STATE OF MAINE
DEPARTMENT OF TRANSPORTATION
16 STATE HOUSE STATION
AUGUSTA, MAINE
04333-0016

January 18, 2007
Subject: **Topsham**
Pin No. 14062.11
Amendment No. 4

Topsham
14062.11
Highway Maintenance Garage
January 16, 2007

DATE 05-19-06	SCALE AS SHOWN	JOB NO LP ENG 20-1-97	DRAWING NO A-8B
BY L. P. Pelletier	CHKD

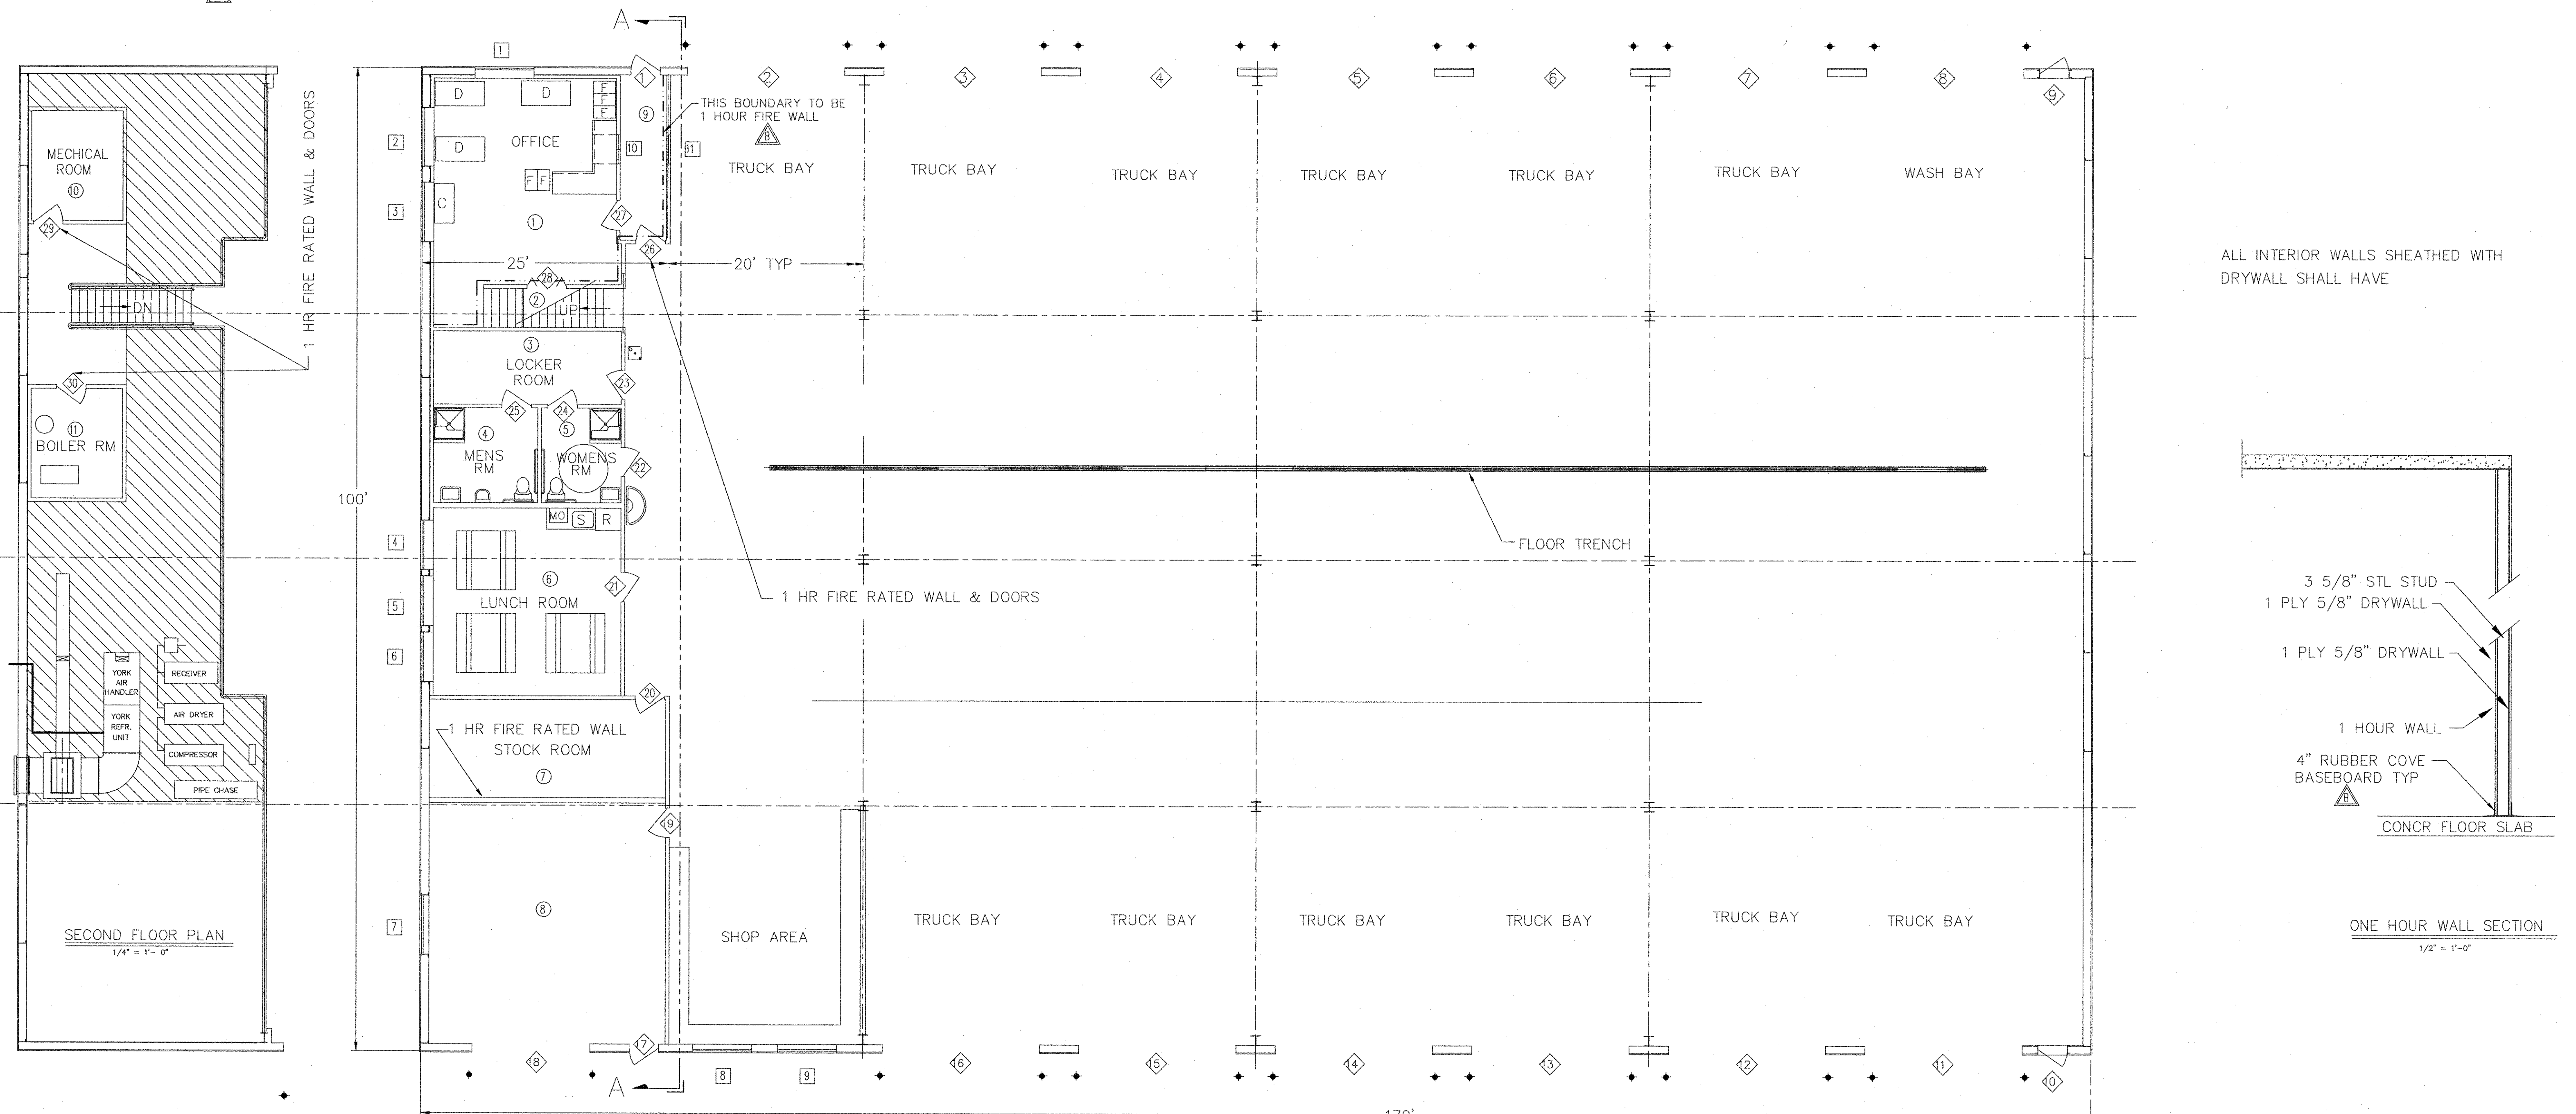
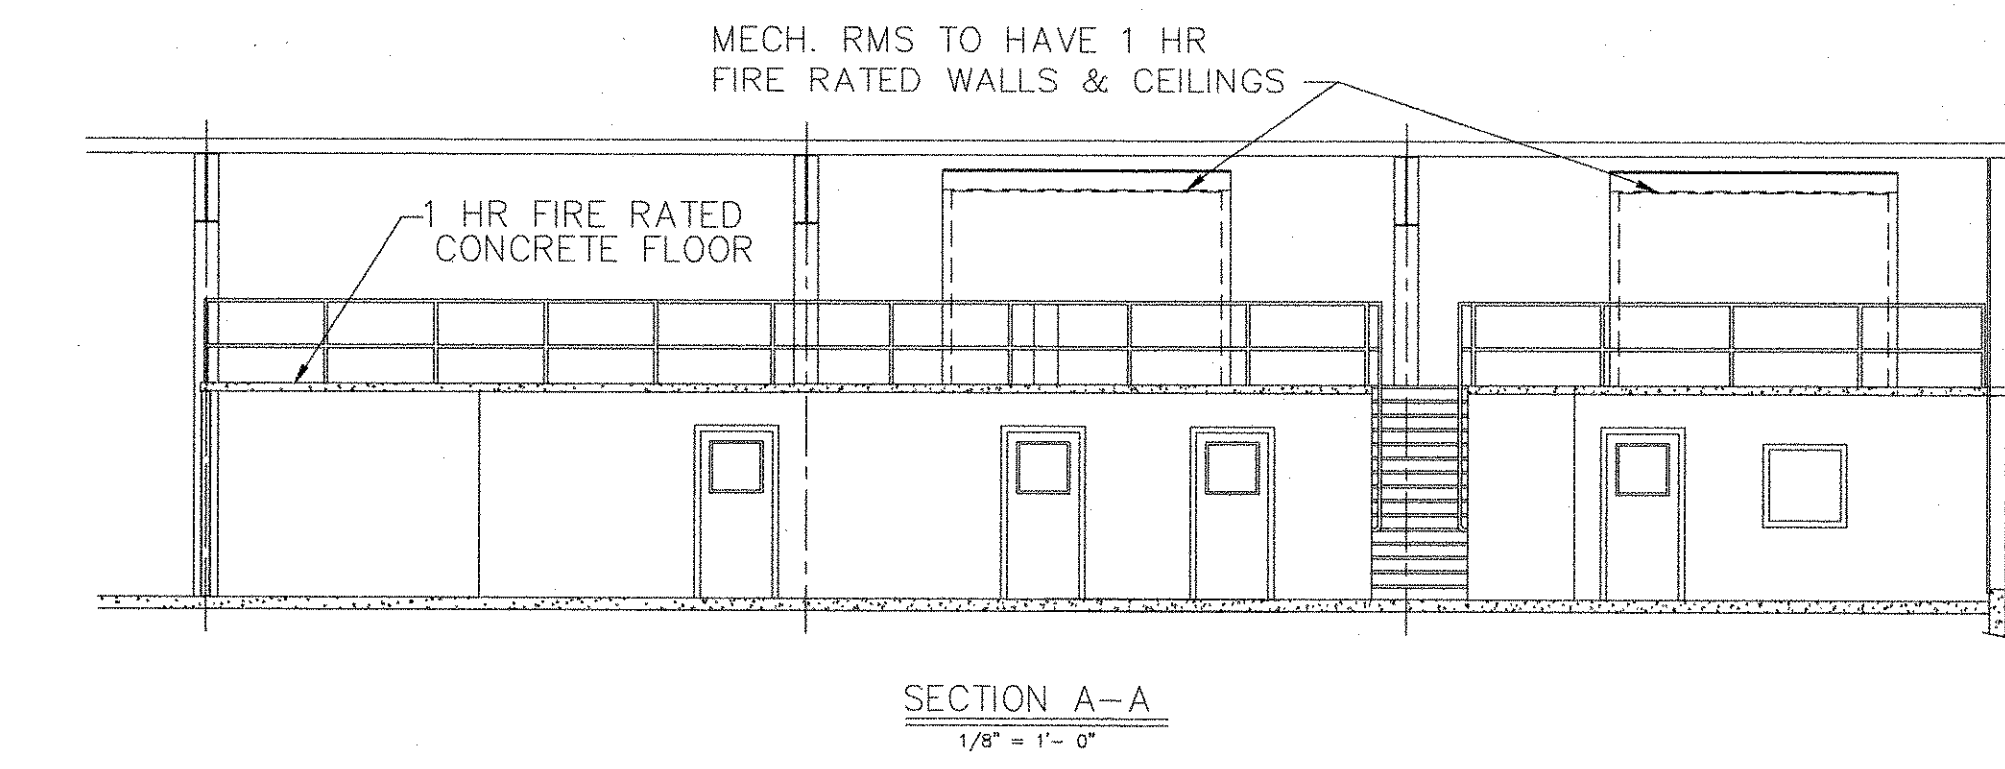
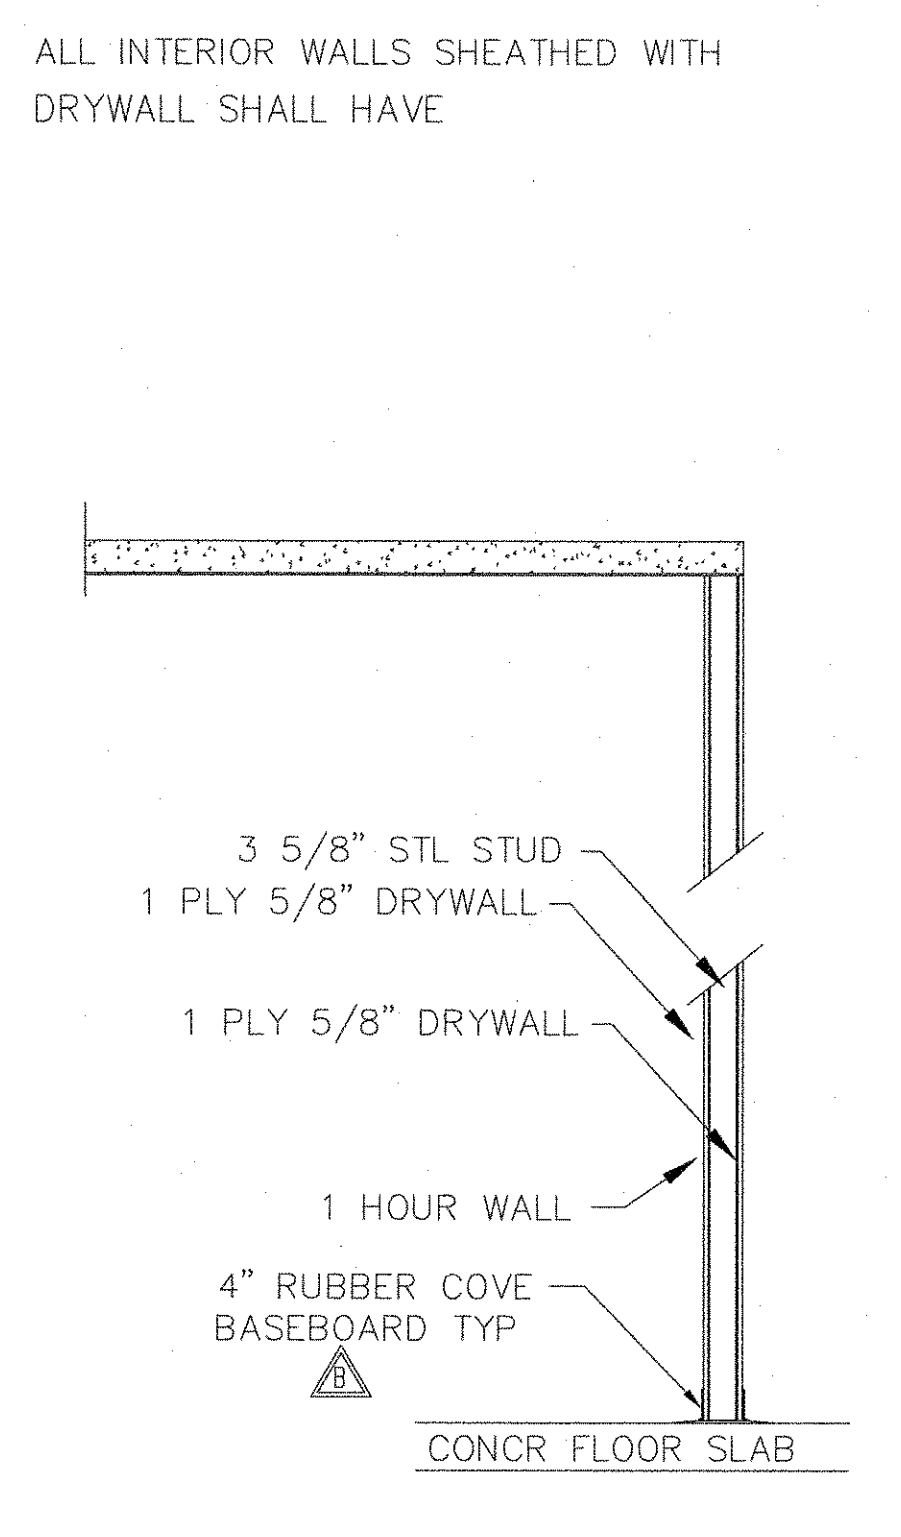
REMOVE the existing plan sheet A-8 titled: “Building Schedules” and REPLACE with the attached updated A-8B: “Building Schedules”.

DELETE any reference to Doors 22 and 23 showing glazing, these doors are to be solid. Make this change in pen and ink.

Question: Door 19/20/21/26/27 is drawn with 24" x 24" wired glass. Maximum wire glass in a fire rated door is 100% wire inches- 10" X 10" or 4" x 25"

Question: Are doors 26/27 fire rated?

Question: Does the exterior wall get metal framing? Drywall? Is it limited to the office? Mezzanine? Warehouse? Are the first floor walls framed with metal studs? Do they get insulation? What Type? Do all interior walls get gypsum board? Define which ceilings get a metal grid framing?

Question: Page A-8 finish schedule indicates 2 layers of 5/8 at walls. Plans call for 1 hour walls which are 1 layer 5/8. Please clarify if one hour or two layers are wanted on walls.

Response: Door 26 is to be fire rated and 10" square glass shall be used. See attached plan sheet A-8B.

Response: Door 26 is fire rated. See attached plan sheet A-8B.

Response: See "Notes" on attached plan sheet A-8B added earlier in this amendment.

Response: See one hour wall section and schedule on attached plan sheet A-8B.

SITE UTILITIES PLAN - WEST

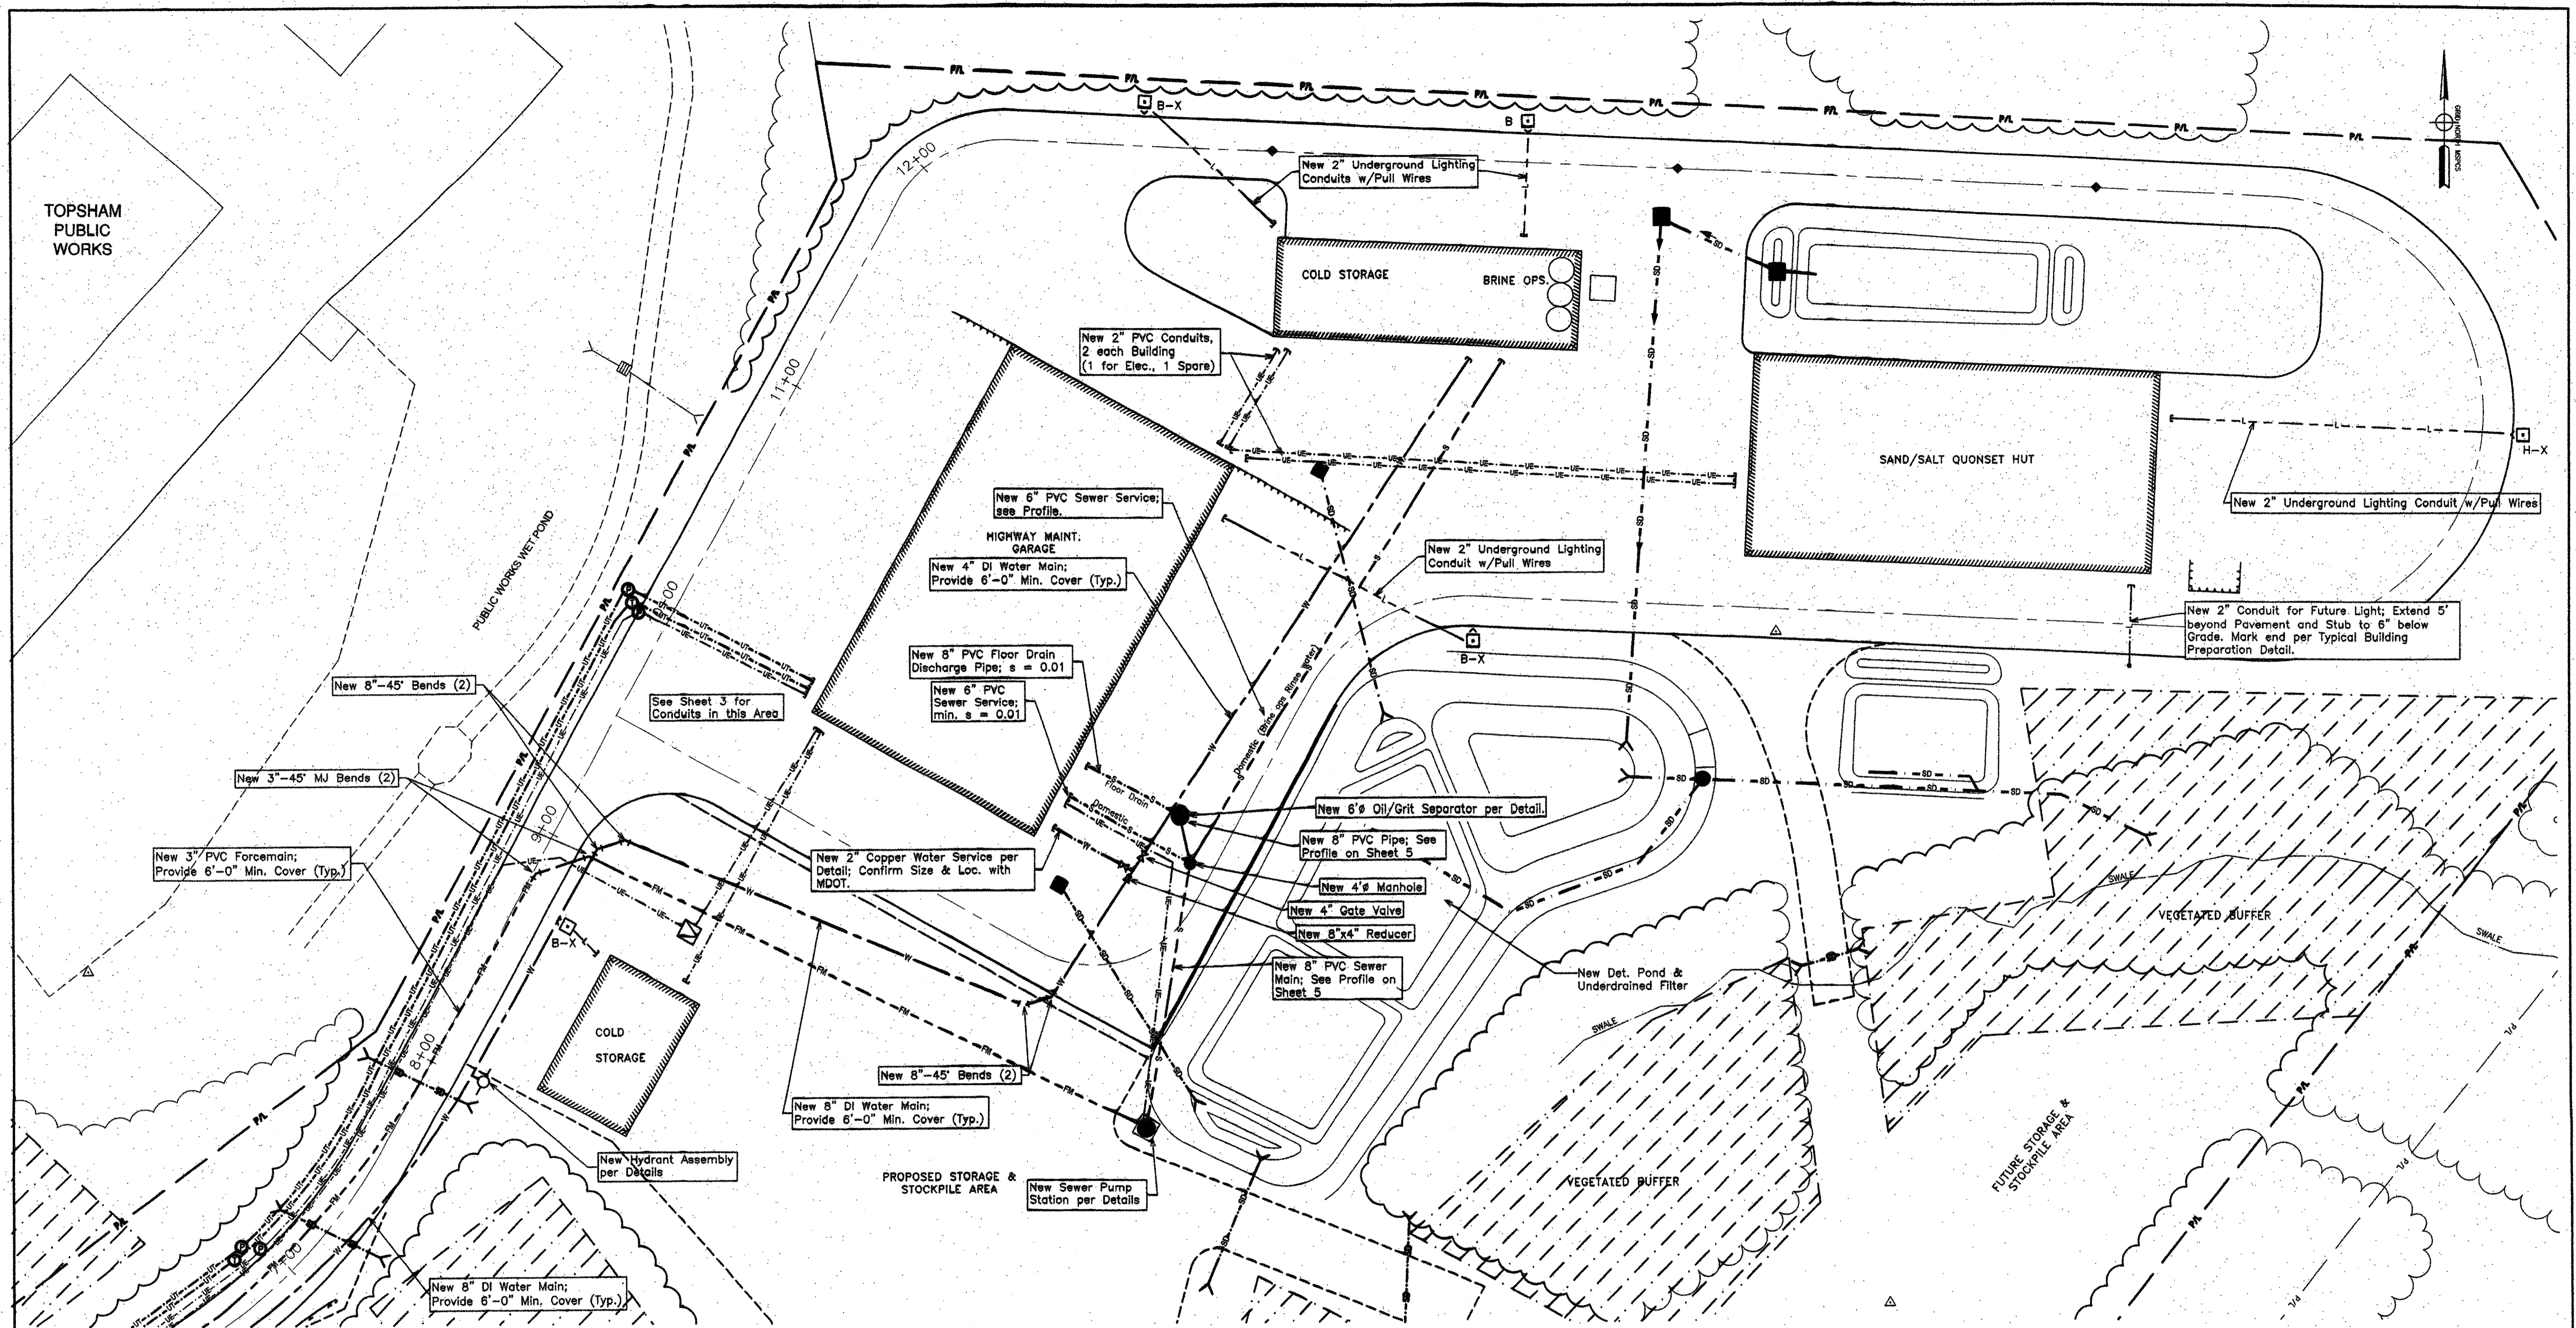
Question: Is it the intent of the drawing to show that the Electrical Primary feed is already within the property boundaries and stops where the bold line on the drawing begin?

Question: Can't find reference to where existing Pin 14062.10 work ends and 14062.11 begins on prints.

Response: The contractor’s work will begin where the existing PIN 14062.10 Topsham Maintenance Facility Site Work Project ends. Please see revised Special Provision Section 16410 Electrical Work, 2.15 “Electrical Service and Distribution System”

Response: Refer to the attached sheets 3 and 4 of plans for project 14062.10 but field modifications have been made to project 14062.10 .
